STAFF REPORT
COMMUNITY DEVELOPMENT DEPARTMENT

DATE: 3/2/2021
 TO: Mayor & City Council
 FROM: Joseph Dodson, Associate Planner
 208-884-5533
 SUBJECT: FP-2020-0020
 Jocelyn Park No. 2

I. PROJECT DESCRIPTION

A final plat consisting of twenty-five (25) building lots and one (1) common lot on 3.26 acres of land in the R-8 zoning district. *This is the second and final phase for Jocelyn Park Subdivision (H-2020-0067).*

C. Landscape Plan (dated: December 18, 2020)

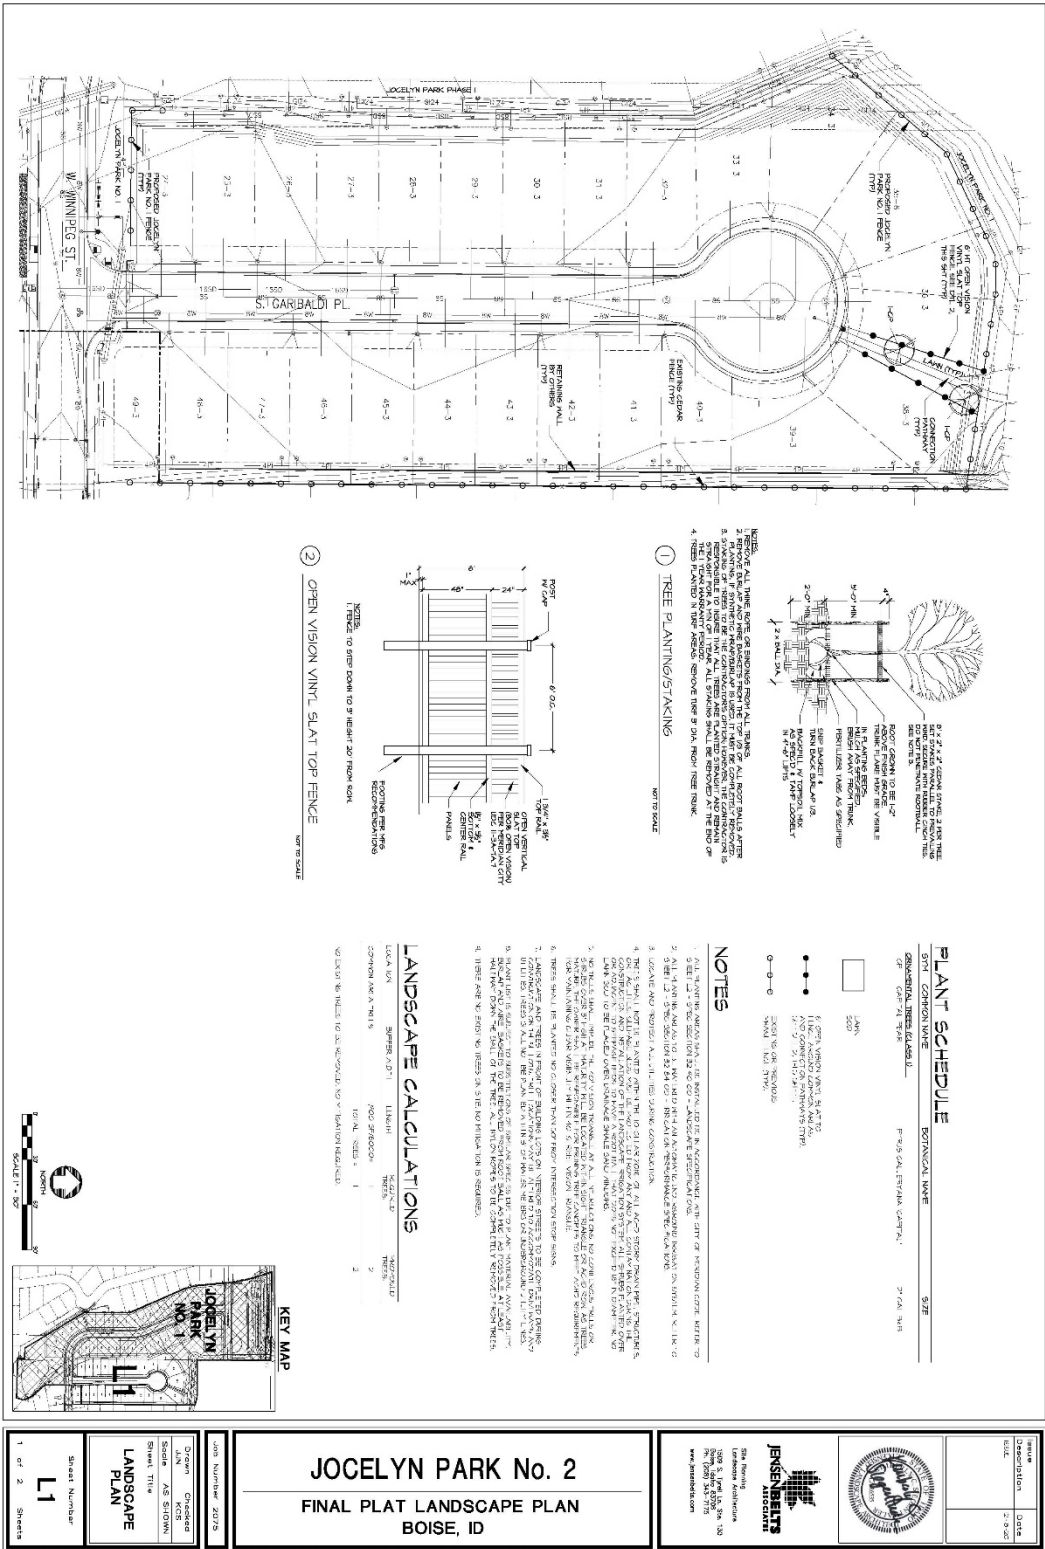
- d. Widen the micro-path lot abutting the cul-de-sac to be at least 15 feet wide, in accord with UDC 113A-8; revise building lots as needed.
5. Prior to signature on the final plat by the City Engineer, the landscape plan prepared by Jensen Belts Associates (Exhibit C), dated December 18, 2020, shall be revised as follows:

- a. Revise the micro-path lot abutting the cul-de-sac in accord with the plat condition above.
6. The applicant shall comply with the submitted home elevations within the approved preliminary plat (H-2020-0067).
